STAFF REPORT
COMMUNITY DEVELOPMENT DEPARTMENT

SUBJECT: FP-2021-0051
Gander Creek North Subdivision No. 2

I. PROJECT DESCRIPTION

Final plat consisting of 48 buildable lots and 9 common lots on 11.71 acres of land in the R-8 zoning district

B. Final Plat (12/17/2021)

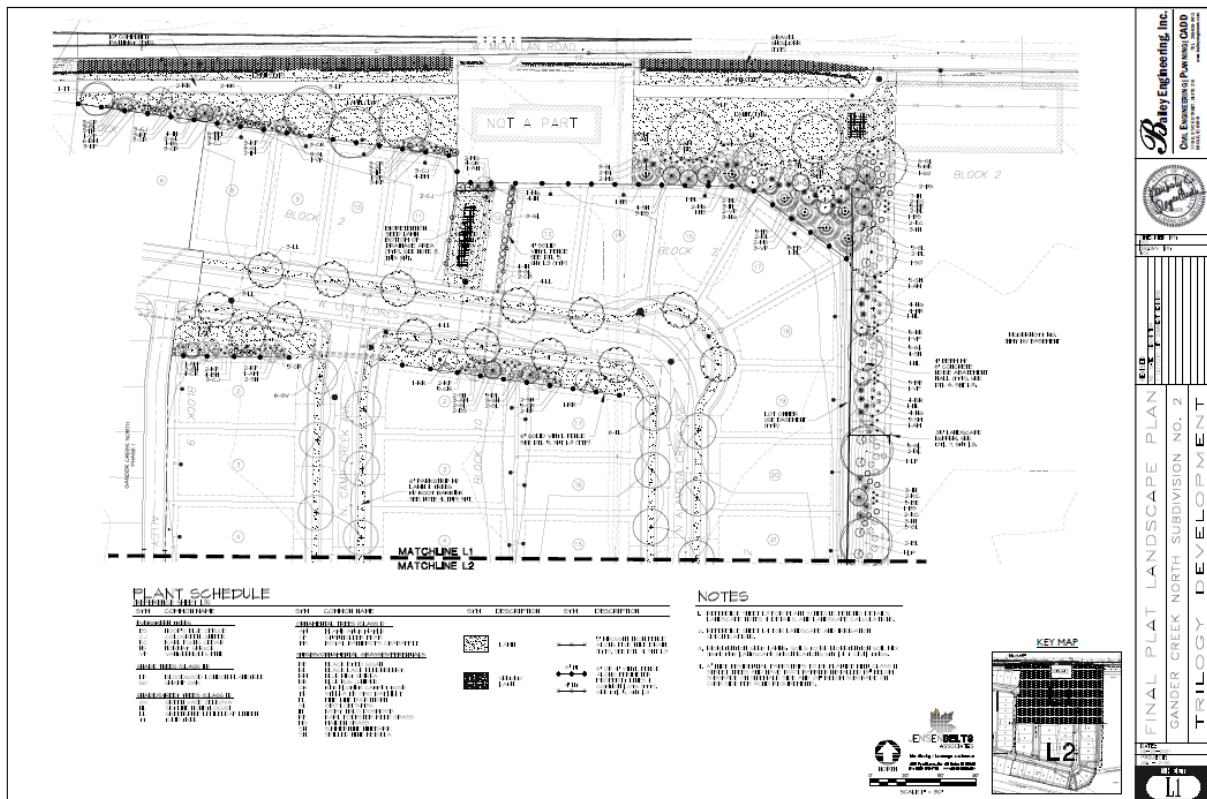
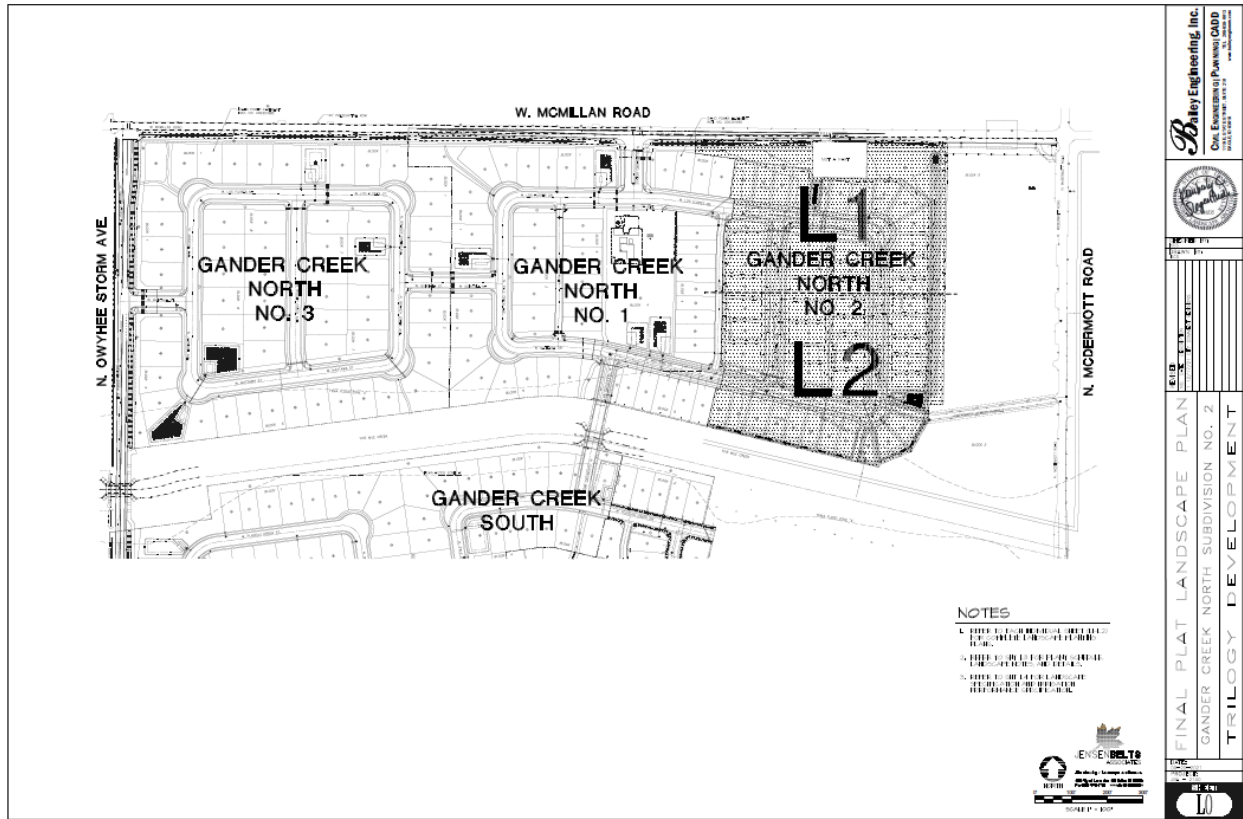
- a. Note #2: Include Lot 12, Block 2 as also containing the ACHD storm water drainage system.
 - b. Note #10: Include the recorded Instrument Number for the ACHD Permanent Easement.

- c. Note #11: Include the recorded Instrument Number of the ACHD License Agreement.
 - d. Note #12: Include the recorded Instrument Number of the City of Meridian Water & Sewer Easement.

- e. Note #13: Include the recorded Instrument Number of the Meridian pathway easement.
 - f. Note #14: Include the recorded Instrument Number for the ACHD Permanent Easement. *Is this a duplicate note (see Note #10)?*

- g. Berm detail on Sheet 3.4 of the construction drawings: Increase the height of the berm to 6-feet per requirement of the development agreement.
 - h. Depict local street access as set forth in UDC 11-3A-3 or a common driveway meeting the standards listed in UDC 11-6C-3D to the out-parcel (Parcel #S0432110050) on W. McMillan Rd. per condition #VIII.A.2k of the preliminary plat.

- i. The use easement described in Note #15 and graphically depicted on the plat is supposed to go to the top of the berm to the wall; it appears to stop short of that location – revise accordingly.

C. Landscape Plan (dated: 12/17/2021)

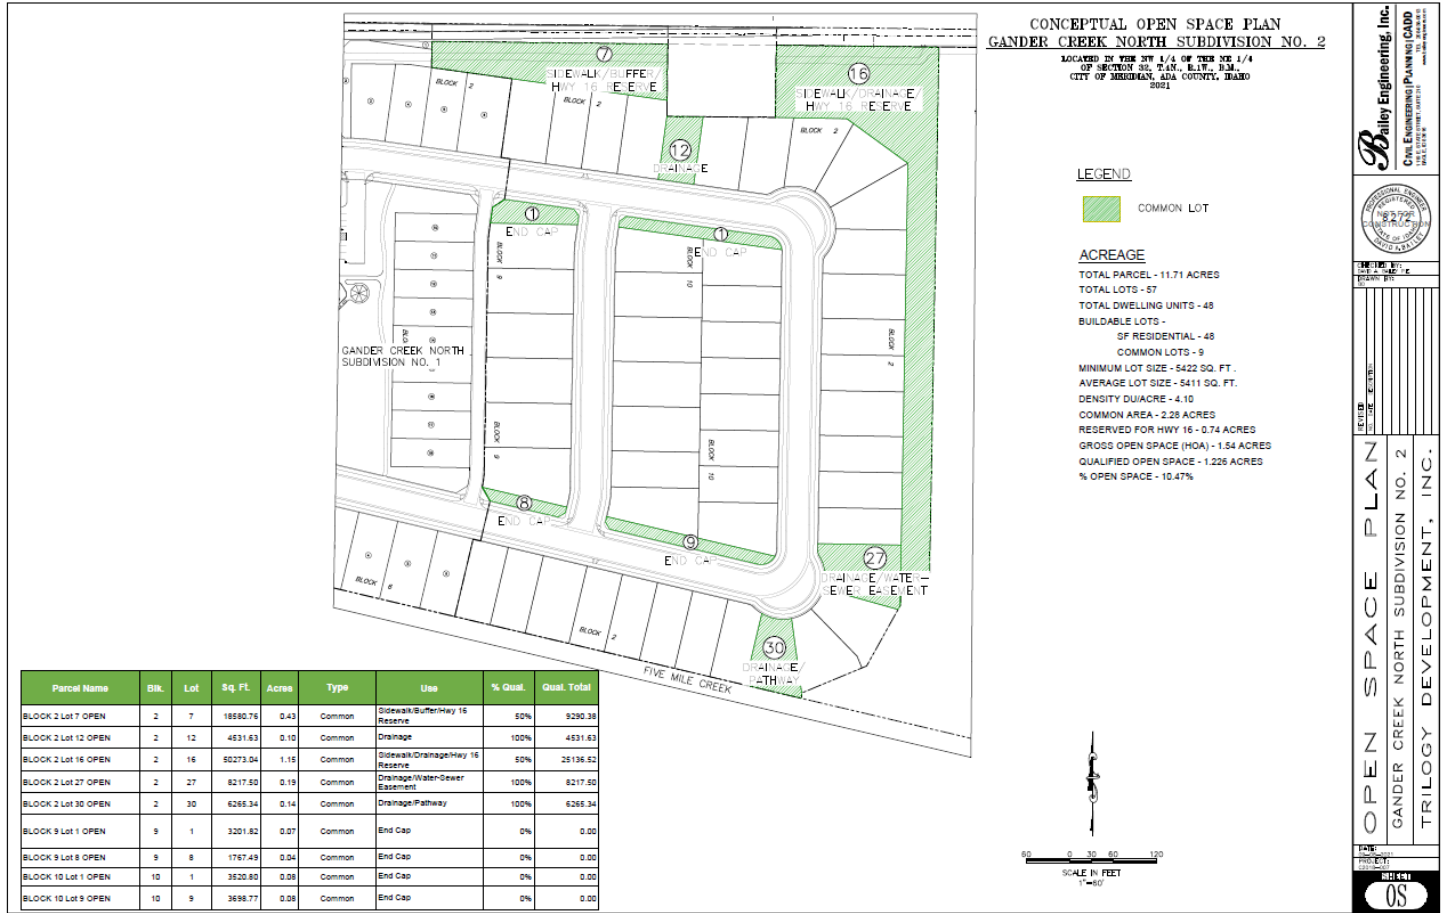
5. The landscape plan prepared by Jensen Belts Associates, dated 09/20/2021, included in Section V.C, shall be revised as follows:
 - a. A minimum 35-foot wide street buffer is required along future SH-16 measured from edge of right-of-way to the wall/fence (typically fences are required to be placed on the interior edge of the street buffer per UDC [11-3B-7C.2c](#) but in this case the wall needs to be installed at the top of the berm in order to comply with the noise abatement standards in UDC 11-3H-4D). *If the common lot needs to be widened to accommodate this requirement, the plat shall be amended accordingly. Depict the edge of right-of-way on the plan.*

- b. Increase the height of the berm along the east boundary of the site from 4-feet to 6-feet tall with a 6-foot tall wall on top of the berm as proposed per requirement of the development agreement.

- c. Depict local street access as set forth in UDC 11-3A-3 or a common driveway that complies with the standards listed in UDC 11-6C-3D to the out-parcel (Parcel #S0432110050) on W. McMillan Rd. per condition #VIII.A.2k of the preliminary plat.

- d. Include a detail that depicts the centerline (or estimated centerline) of future SH-16 in relation to the top of the berm/wall verifying it's a minimum of 12 feet higher than the elevation at the centerline of the state highway as required by UDC 11-3H-4D.2, per preliminary plat condition VIII.A.3b. *The Director may approve alternative compliance as set forth in UDC 11-5B-5 where the Applicant has a substitute noise abatement proposal in accord with ITD standards and prepared by a qualified sound engineer as set forth in UDC 11-3H-4D.4.*

- e. Depict a use easement across the back side of the berm on Lot 16, Block 2 adjacent to future SH-16 benefitting adjacent building lots with allowance for side yard fences to be constructed to the wall on top of the berm per preliminary plat condition #VIII.A.3f. *The use easement depicted on the plan doesn't appear to go to the top of the berm.*

- f. Depict off-site landscaping on NMID's property at the southeast corner of the site as depicted on the landscape plan submitted with the preliminary plat if allowed by NMID through a license agreement.
